APPLICATION FOR LAND USE CONSISTENCY DETERMINATION  
San Mateo County Airport Land Use Commission  
C/CAG ALUC

Project Name: 271 El Camino Real multifamily housing project

**Subject: San Francisco International Airport's Comments on the Land Use Consistency Determination for 271 El Camino Real Multi-Family Housing Project**

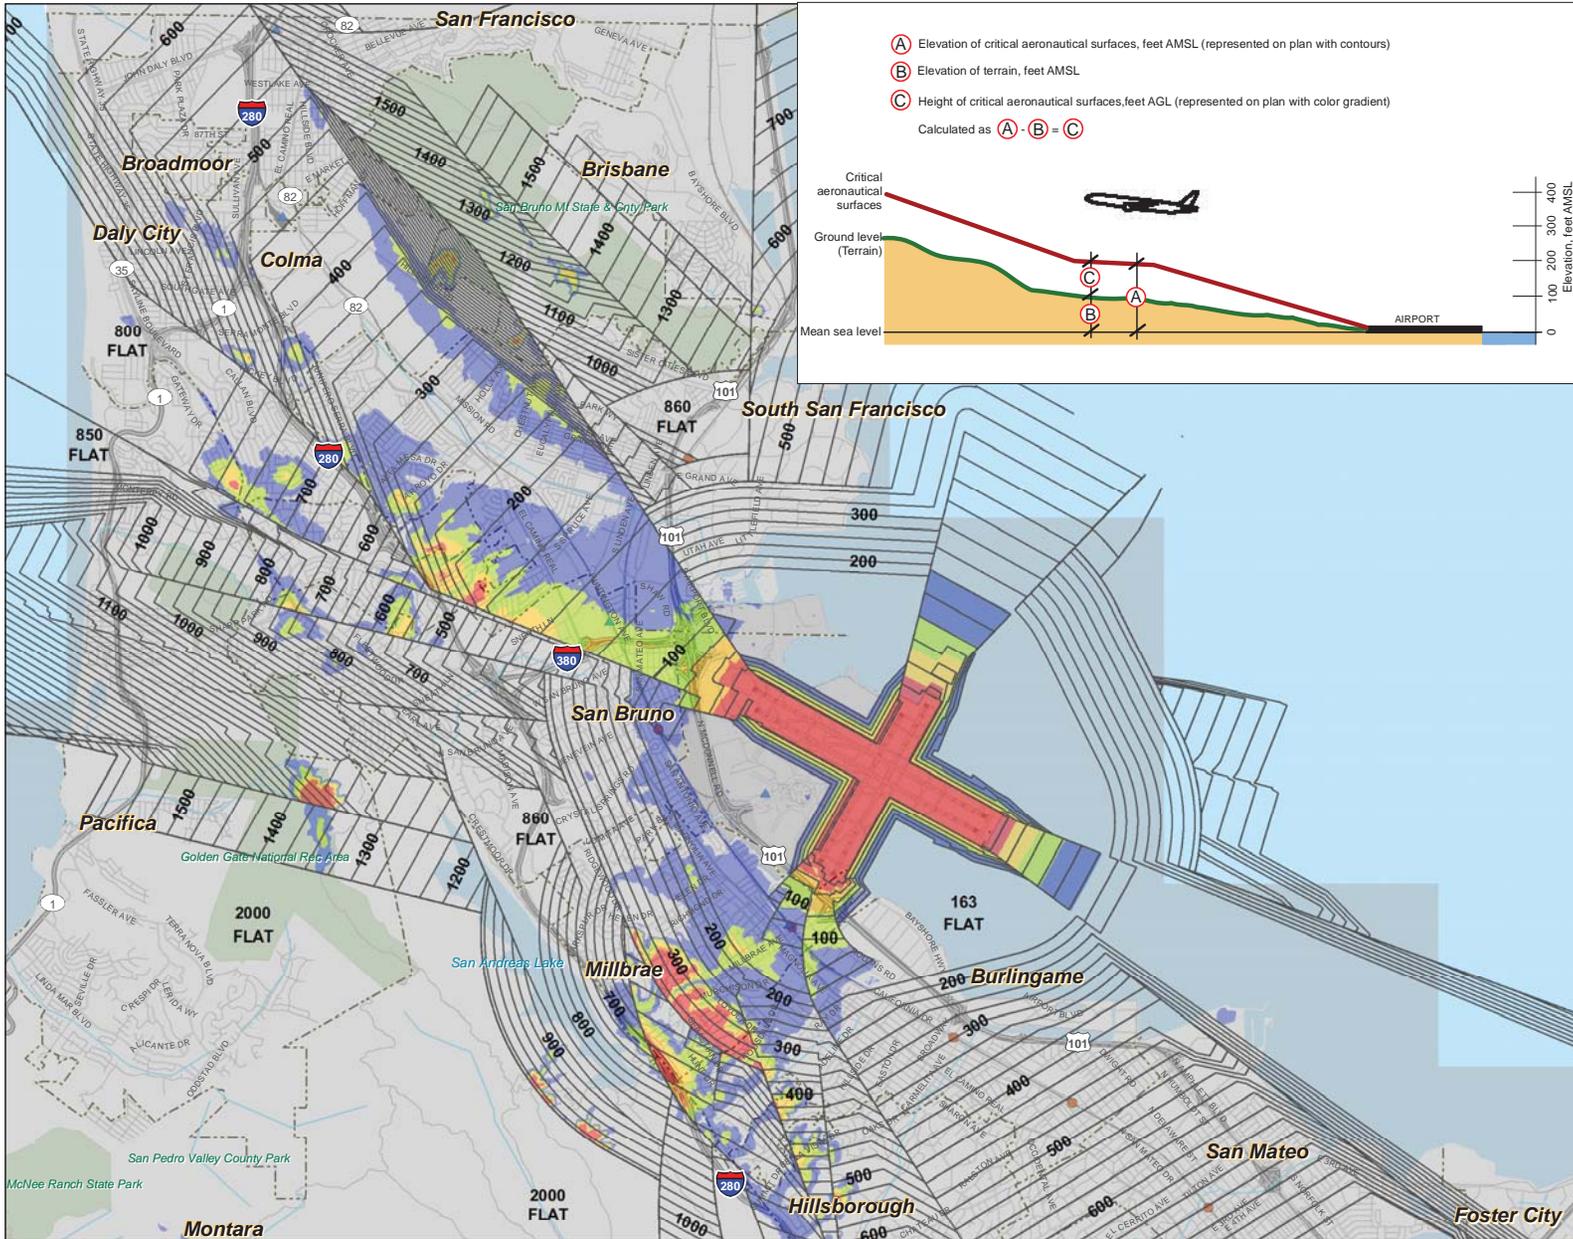
The Proposed Project is located beneath the critical aeronautical surfaces for Airport operations. As described in Exhibit IV-17 (see **Attachment A**) of the SFO ALUCP, the elevations of the critical aeronautical surfaces above the Proposed Project site are at least 150 feet above mean sea level, as defined from the 0-foot origin of the North American Vertical Datum of 1988 (AMSL NAVD88). Ground elevation at the Proposed Project site ranges from 47 to 60 feet AMSL NAVD88. While the drawings provided do not include a translation between the local vertical coordinate system and a standard vertical datum, the Proposed Project appears to be no taller than 56 feet tall, and so it would not appear to be incompatible with the airspace protection requirements of the SFO ALUCP.

The Airport emphasizes that no portion of the permanent structures, including any antennas, appurtenances, davits, or architectural parapets, may penetrate the critical aeronautical surfaces of the SFO ALUCP.

This evaluation does not waive the requirement for any developments which result from the Proposed Project to undergo Federal Aviation Administration (FAA) airspace review as described in 14 Code of Federal Regulations Part 77 and in Exhibit IV-10 of the SFO ALUCP (see **Attachment A**) for both (1) the permanent structures and (2) any equipment taller than the permanent structures required to construct those structures. A Determination of No Hazard from the FAA must be obtained prior to project approval.
